**To:** Brendan Waights  
**Project:** LOT 9 – 18 Alexander Street, Collaroy  
**Report:** BCA Assessment Report  
**Reference No:** 111559-BCA-r1.1 (LOT 9)  
**Date:** 26/02/2020  
**Client Contact:** Scott Walsh  
**Email:** [scott@walsharchitects.com.au](mailto:scott@walsharchitects.com.au)  
**From:** Ben Long  
**Direct:** 8484 4009  
**Email:** [blong@bcalogic.com.au](mailto:blong@bcalogic.com.au)

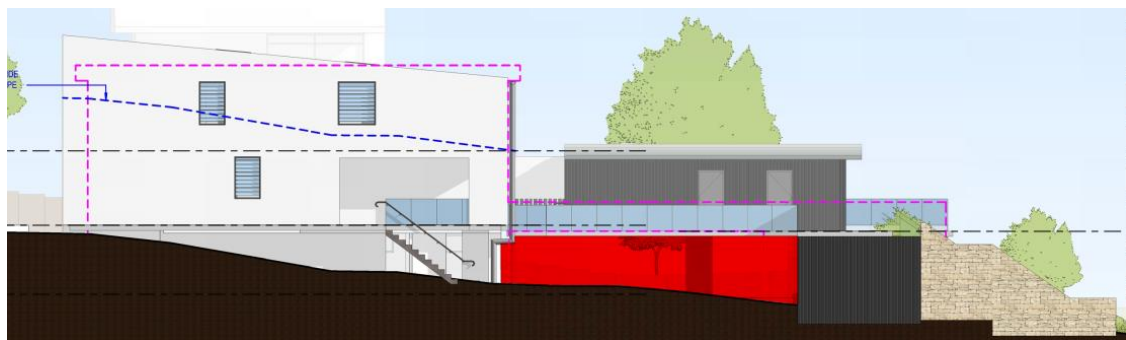
There are several openings provided within proximity to the boundary that will need to be provided with protection in accordance with Clause C3.4.

However it is noted that the open nature of the carpark has led to openings being provided between the slab levels that will need to be protected. Based on the nature of the openings it is considered that methods of protection would be limited unless blade walls are provided along the boundaries.

It would be possible to seek a Performance Solution to allow for a lack of protection being provided to these openings due to the driveways being kept clear, however it is considered that the openings on the western elevation would need to be protected with blade walls due to the proximity of the cars to the openings. The openings located adjacent to the stair on the eastern elevation would also need to be infilled.

The red shaded section below identified the openings that may be addressed under the Performance Solution.
